UNITED STATES PATENT AND TRADEMARK OFFICE

APPLICATION NO.	FILING DATE	FIRST NAMED INVENTOR	ATTORNEY DOCKET NO.	CONFIRMATION NO.
10/712,099	11/14/2003	Yoshio Kinoshita	XA-9986	8222

Office Action Summary

DETAILED ACTION

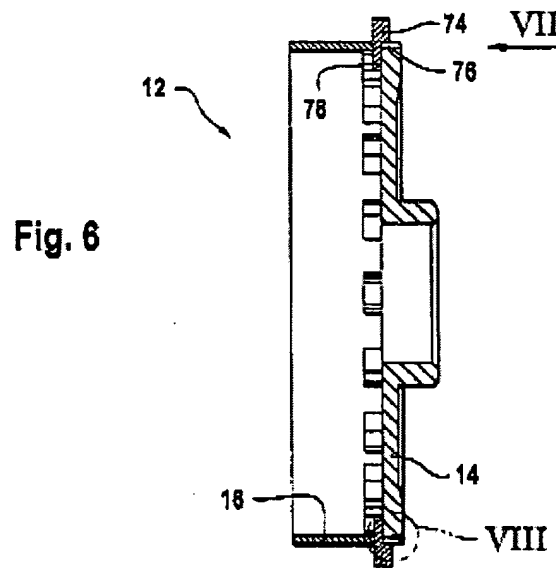
Claims 5-8 and 13 are rejected under 35 U.S.C. 102(b) as being anticipated by Pinschmidt et al. ('276).

Pinschmidt et al. discloses a multi-plate clutch (Fig. 6) with engagement elements (28, 36), a cylindrical case (16), a tone wheel (74), and fluid ports (56, 58, 76).

Concerning the method limitations (claims 6 and 8), the method of forming the device is not germane to the issue of patentability of the device itself. Therefore, this limitation has not been given patentable weight. Also, although the tone wheel of the prior art is nearer the closed end of the clutch case, for examination purposes it is considered to be near the open end.

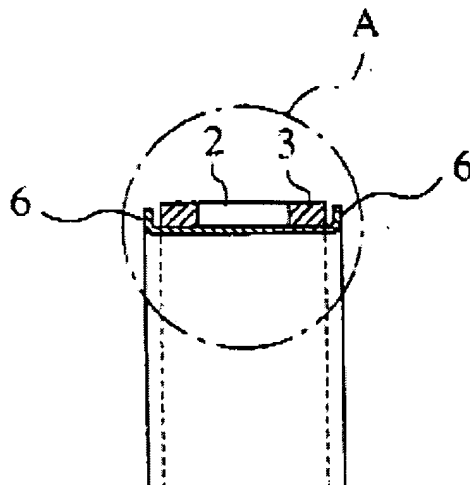
Claims 9-12 are rejected under 35 U.S.C. 103(a) as being unpatentable over Pinschmidt et al. in view of Kumamoto et al. ('575).

Pinschmidt et al. does not teach a tone wheel with openings. Kumamoto et al. discloses a tone wheel with slit-like openings for detecting the position of the wheel/case. Then, it would have been obvious to a person of ordinary skill in the art at the time the invention was made to use a tone wheel with slit-like openings in the device of Pinschmidt et al. in view of Kumamoto et al. to improve the accuracy of the device.
